Village of Arlington Heights
Plan Commission
Board Room
Arlington Heights Village Hall
33 S. Arlington Heights Road
Arlington Heights, IL 60005
May 9, 2018
7:30 PM

- A. Funtopia at Arlington Downs - 3400 W. Euclid Ave. - PC#18-006
Special Use Permit for Amusement Facility, Large
- B. 1540 N. Arlington Heights Rd. - PC#18-007
Planned Unit Development Amendment for Parking Variation

To: Sam Hubbard, Development Planner, Planning and Community Development
From: Deb Pierce, Plan Reviewer, Building & Life Safety Department
Subject: 3400 W Euclid Ave – SUP for Amusement/Arcade and Restaurant
PC#: 18-006 – Round 1
Date: March 16, 2018

PLAN COMMISSION PC #18-006
Funtopia at Arlington Downs
3400 W. Euclid Ave.
SUP for Amusement/Arcade and Restaurant
Round 1

Exhibit I – Secondary parking area as depicted on the last amendment to the Arlington Downs PUD:

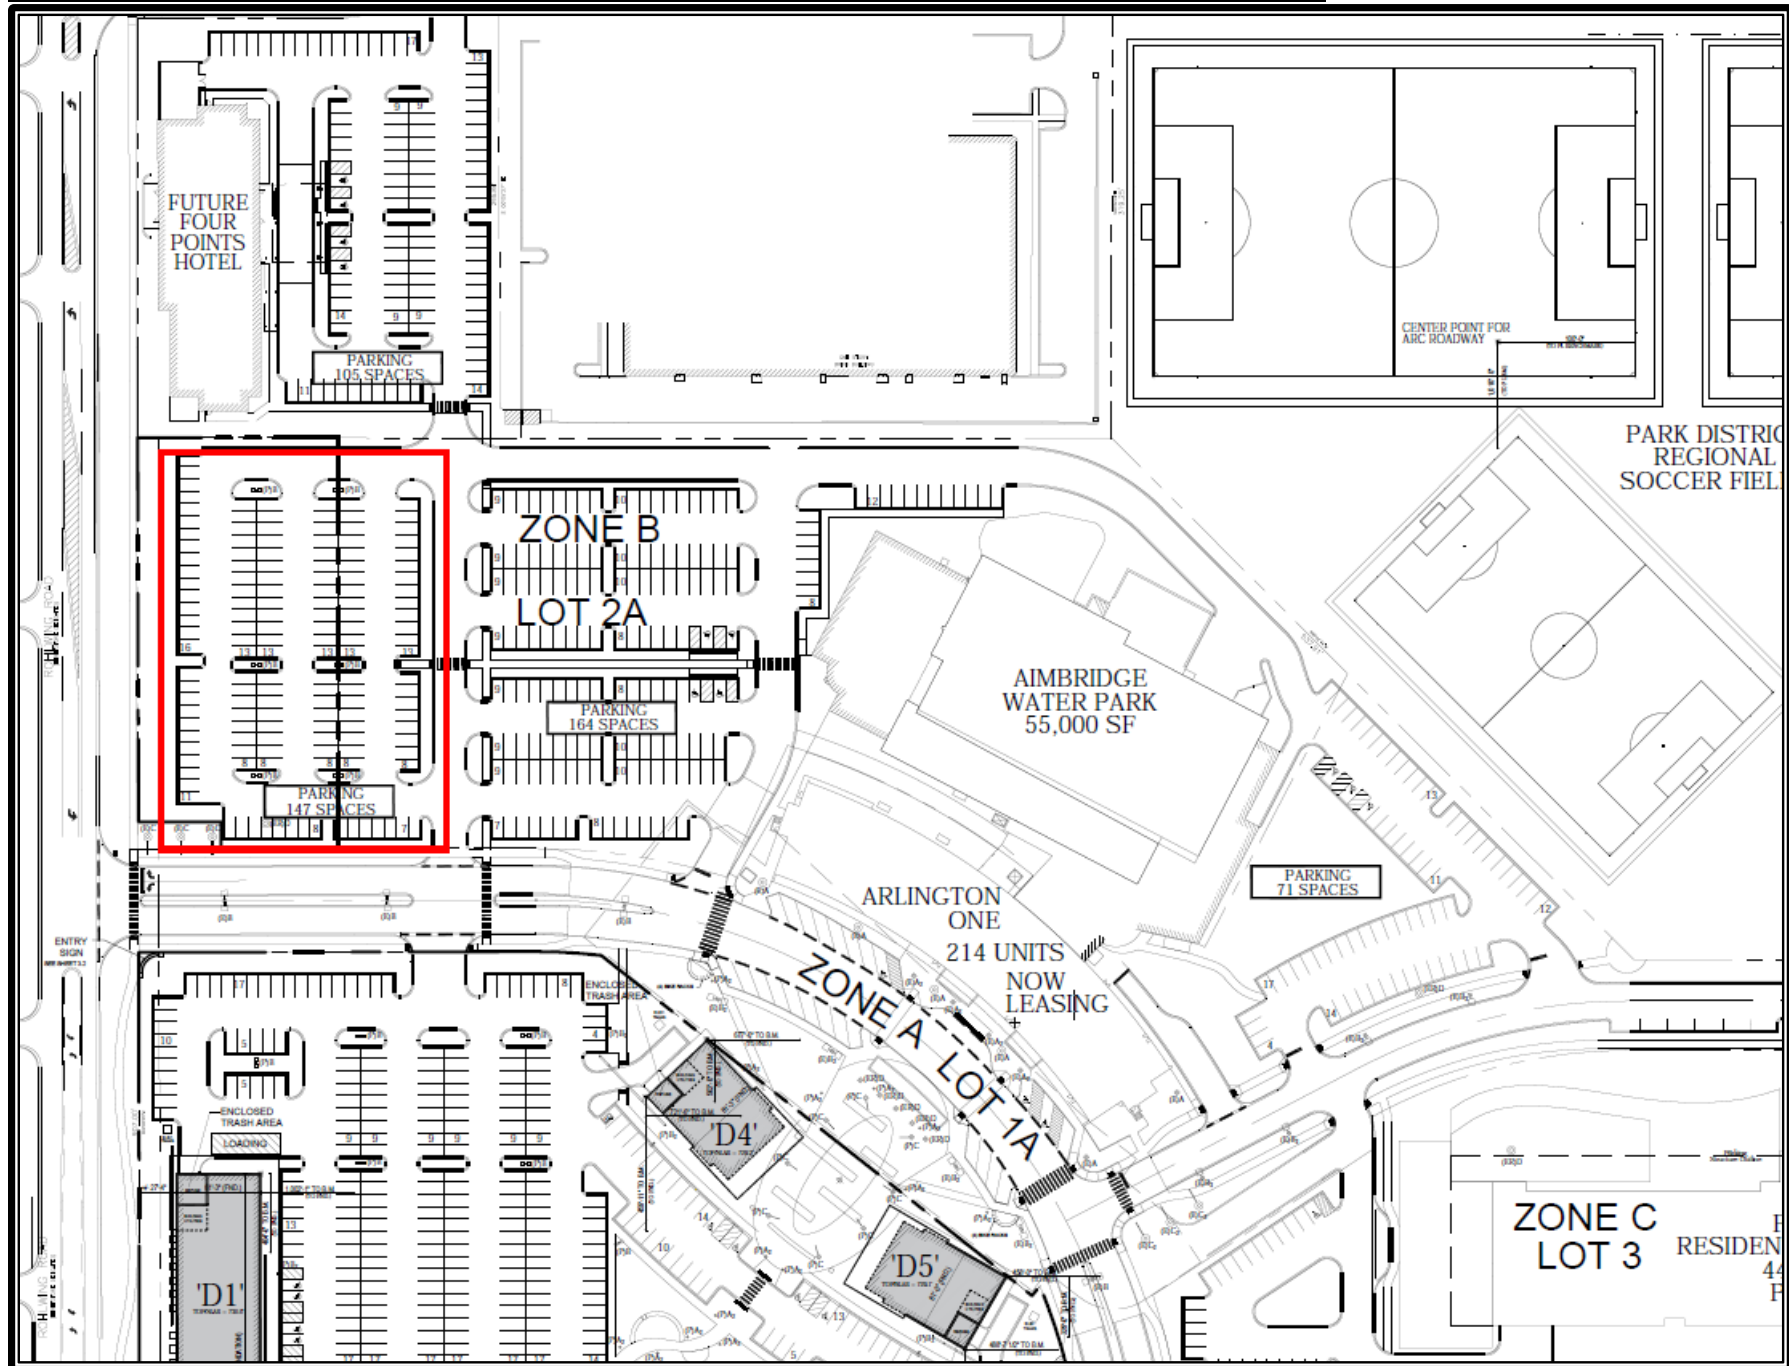
However, as staff has noted, the previous PUD approval included a second parking lot to be located west of the 162-space parking lot immediately adjacent to the waterpark building (see **Exhibit I** at the end of this report with the secondary parking lot outlined in red). This secondary parking area provided overflow parking capacity for an additional 147 cars, which parking area was primarily to be used by the waterpark. Concepts for future amendments to the PUD show this secondary parking area to be instead developed with residential uses, which would eliminate this parking overflow capacity. In order to ensure that the elimination of this secondary parking area will not cause a parking deficit on the site, parking surveys of the PUD will be required once a formal development proposal is submitted for development of Lot 2B and Lot 16. Based on the actual parking demand within the PUD, additional parking on Lot 2B may be required, and a condition of approval addressing this situation has been included within the recommendation below.

PROPOSED SITE PLAN

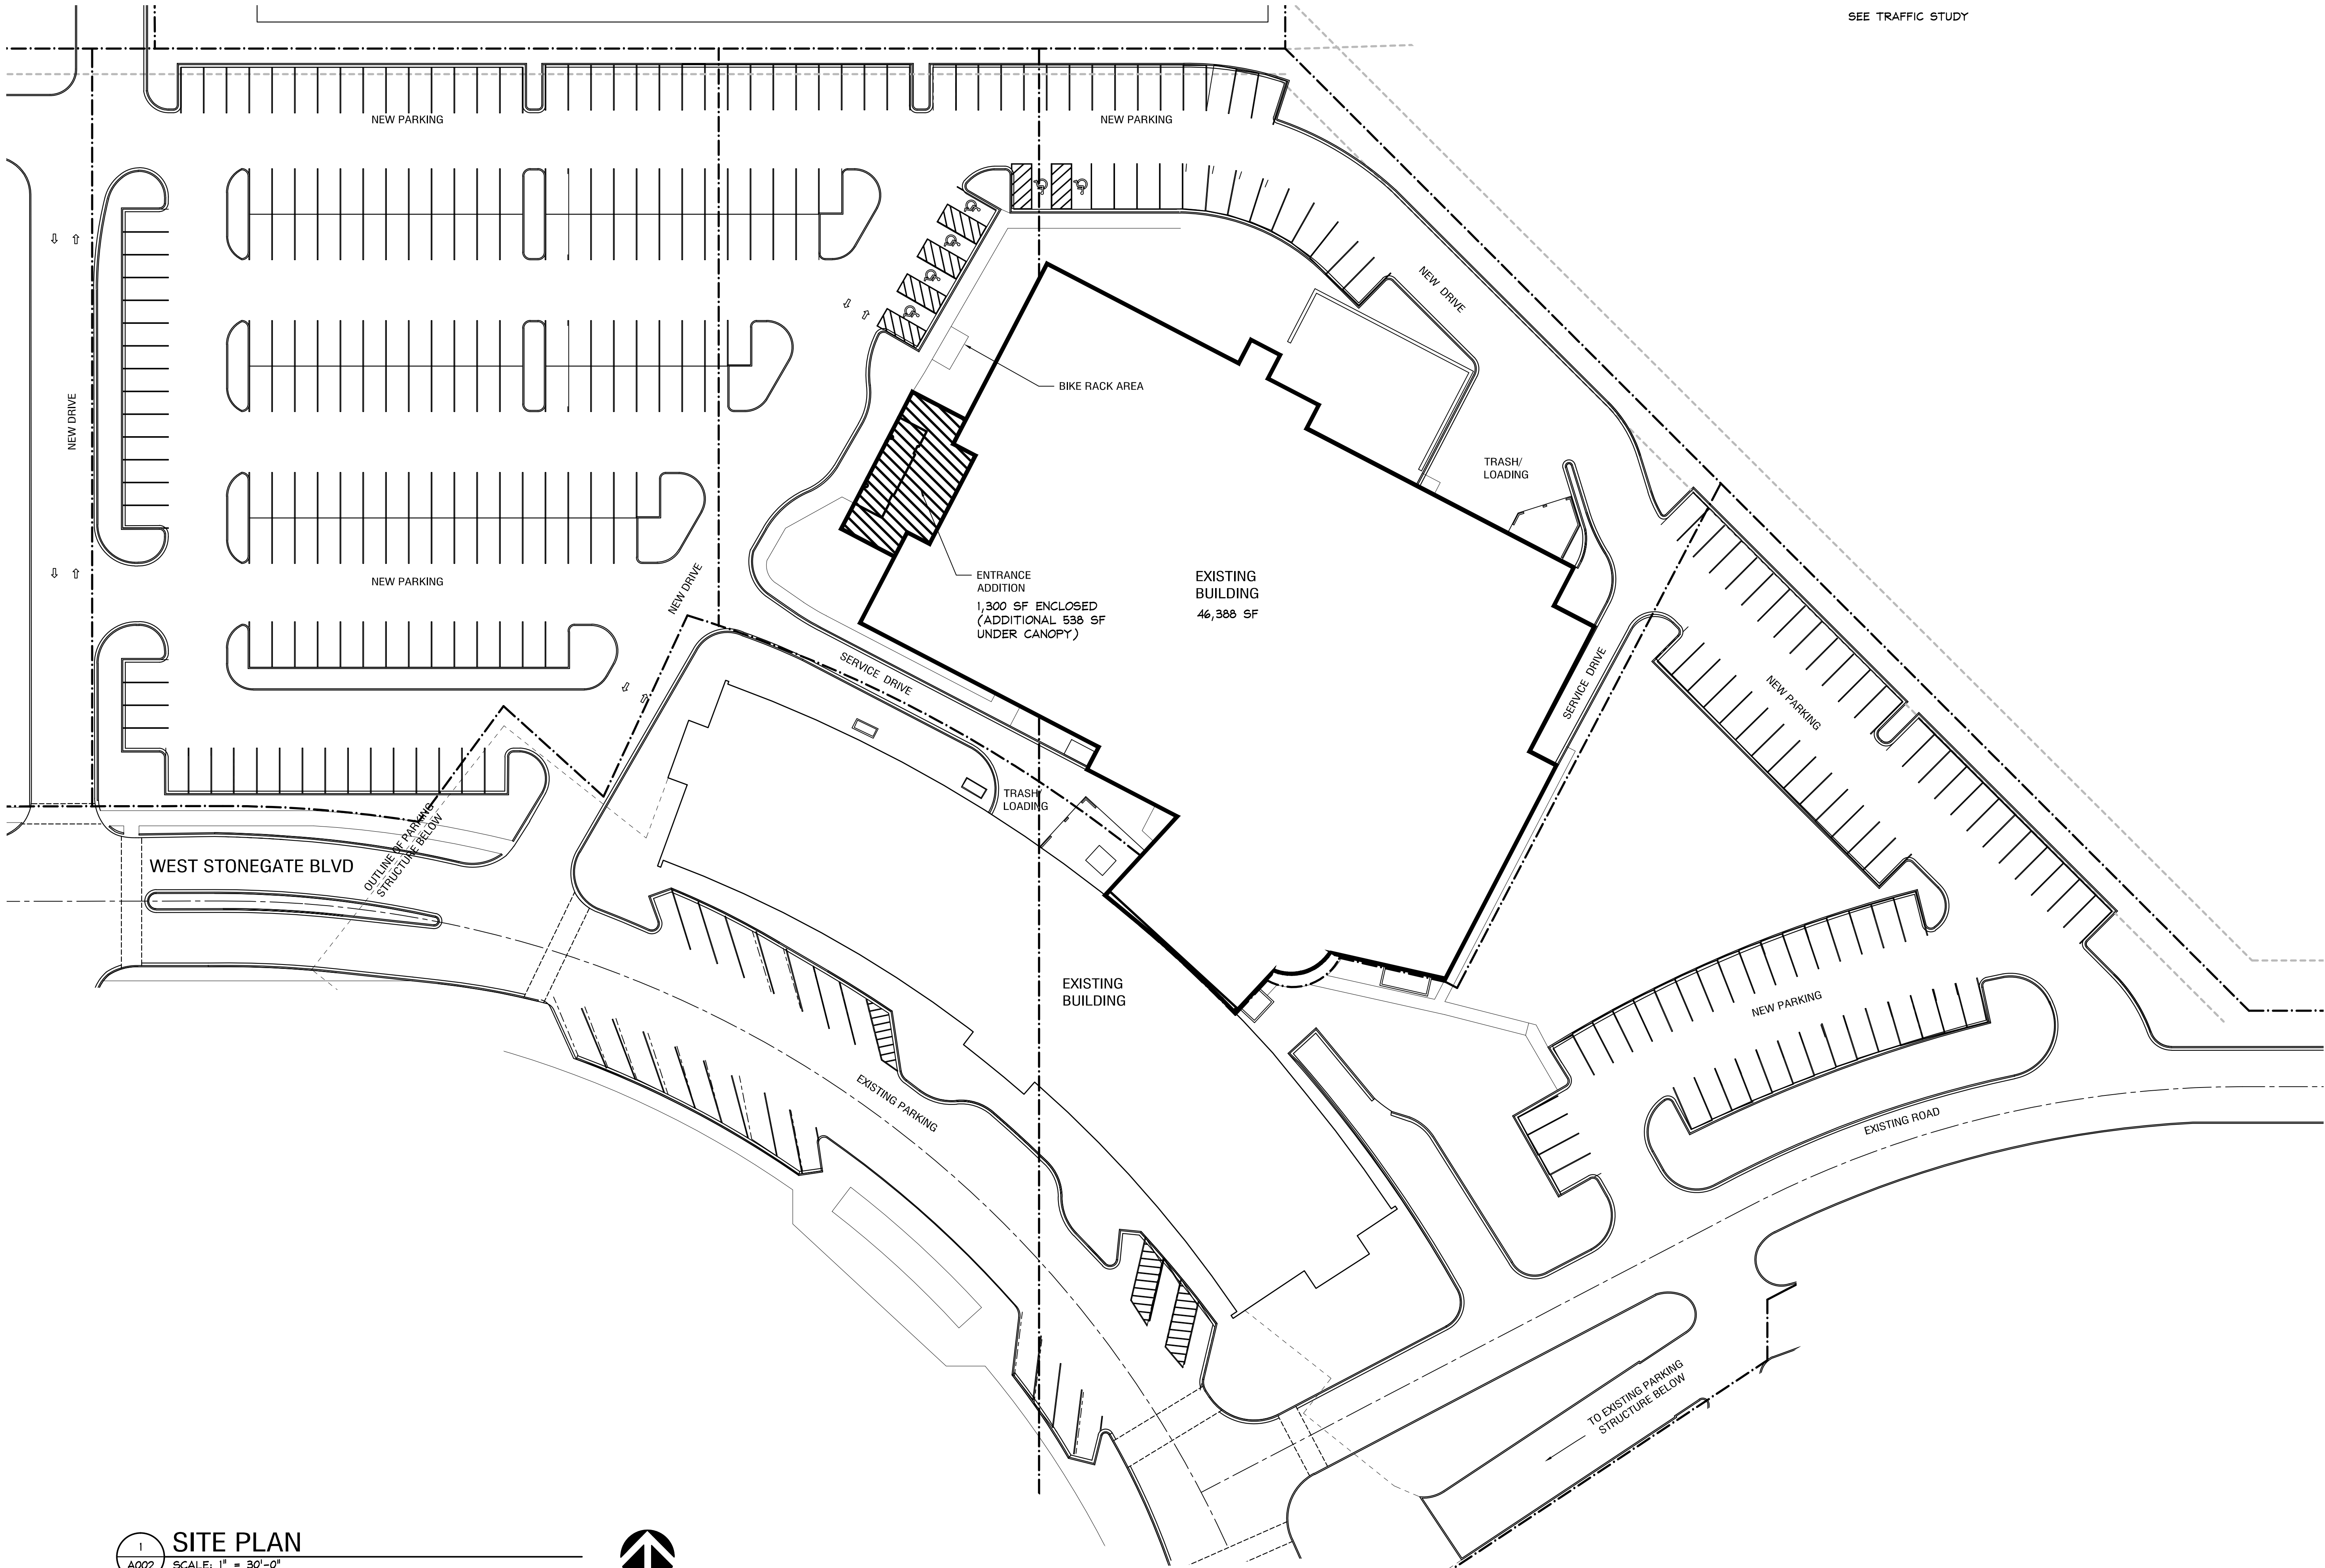
Per the Villages' Bicycle Parking ordinance, the proposed use requires 11 bike parking spaces. The plans indicate a space for bicycle parking racks but do not have details on how many racks/bike parking spaces will be included. A condition of approval requiring 11 bike parking spaces is therefore recommended.

14. A proposed location for a bicycle rack had been indicated on the revised site plan on sheet A001 dated 04-19-2018 submitted with the round 1 responses. The area will be sized to accommodate a minimum of 11 bicycles.
